**QUALITY ASSURANCE -- NON-CONFORMANCE REPORT**

**Location:** Changxing Island, Shanghai, P.R. China**Report No:** NCR-000656**Prime Contractor:** American Bridge/Fluor Enterprises, a JV**Date:** 27-Jan-2010**Submitting Contractor:** Zhenhua Port Machinery Company, Ltd (ZPMC), Changxing Island**NCR #:** ZPMC-0627**Type of problem:**

**Reference Description:** Fabrication not according to the approved shop drawings in Segment 6CE vertical floorbeam flange

**Job Name:** SAS Superstructure

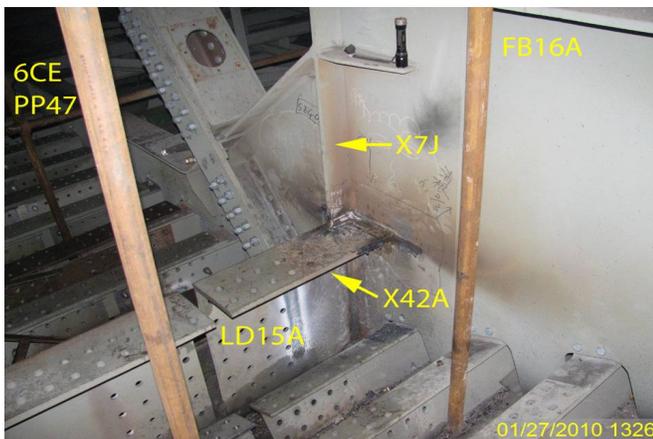
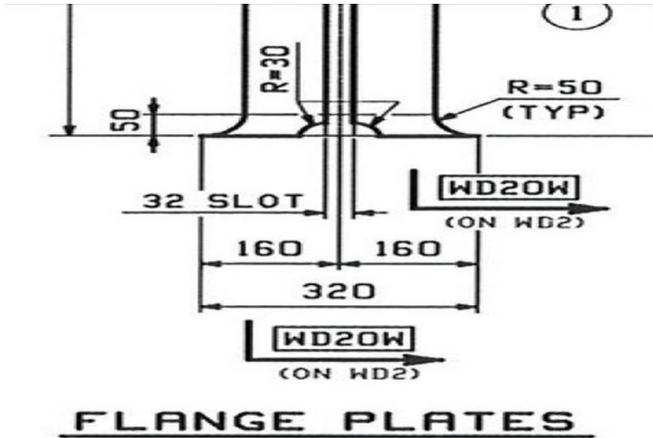
During the Quality Assurance (QA) random in-process visual inspection of the OBG segments in the Trial Assembly area, this QA inspector discovered the following issues:

- Cope Hole R=30mm has been welded (on X7J)
- The R=50mm portion at the transition end of the X7J flange has been trimmed

- At panel point 47, Segment 6CE, Floor Beam FB16A
- The PJP weld joint connecting the vertical floorbeam flange (stiffener) X7J to the Longitudinal Diaphragm LD15A flange plate X42A
- Weld number SEG032D-011

AWS D1.5 2002 Section 3.2.5: Radii of beam copes and weld access holes shall provide a smooth transition, free of notches or cutting past the points of tangency between adjacent surfaces.

AWS D1.5 2002 Section 3.2.5: Reentrant corners of base-metal cut edges shall be formed to provide a smooth transition with a radius of not less than 25 mm [1 in.] that meets the adjacent edges without offset or cutting past the point of tangency. The reentrant corners may be formed by thermal cutting, followed by grinding to meet the surface requirements of 3.2.2.

**Reference Resolution:** ZPMC has excavated the cope hole so it is now in conformance with AWS D1.5 and the approved shop drawings. Attached is the NDT to show that base metal was not damaged during this repair.

The welded cope hole has been excavated and was inspected by CT. ZPMC is providing the NDT records show the affected weld is acceptable. This issue has been removed from punchlist by CT's representative. Based on this, ZPMC requests closure of this NCR.

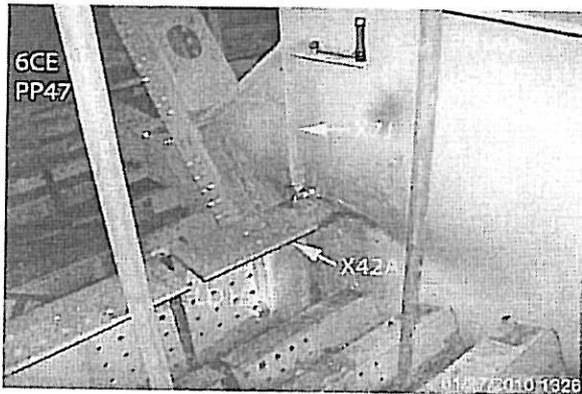
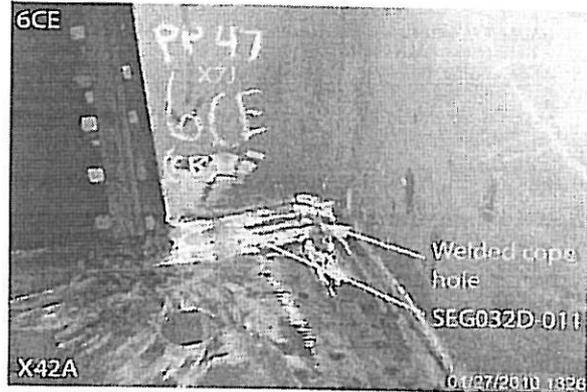
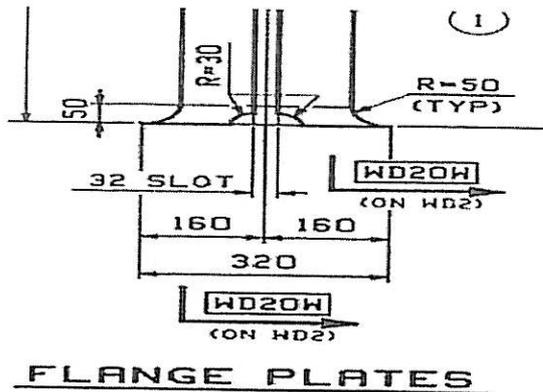
AWS D1.5 2002 Section 3.2.5: Reentrant corners of base-metal cut edges shall be formed to provide a smooth transition with a radius of not less than 25 mm [1 in.] that meets the adjacent edges without offset or cutting past the point of tangency. The reentrant corners may be formed by thermal cutting, followed by grinding to meet the surface requirements of 3.2.2.

AWS D1.5 2002 Section 3.2.5: Radii of beam copes and weld access holes shall provide a smooth transition, free of notches or cutting past the points of tangency between adjacent surfaces.

- Weld number SEG032D-011
- LD15A flange plate X42A
- The PJP weld joint connecting the vertical floorbeam flange (stiffener) X7J to the Longitudinal Diaphragm
- At panel point 47, Segment 6CE, Floor Beam FB16A

-The R=50mm portion at the transition end of the X7J flange has been trimmed

-Cope Hole R=30mm has been welded (on X7J)

Replace cope hole and perform NDT required to verify weld quality.

Contractor removed weld, installed cope hole in conformance with approved Shop Drawings, and submitted subsequent NDT report verifying the weld and base material in the vicinity of the repair were not affected.
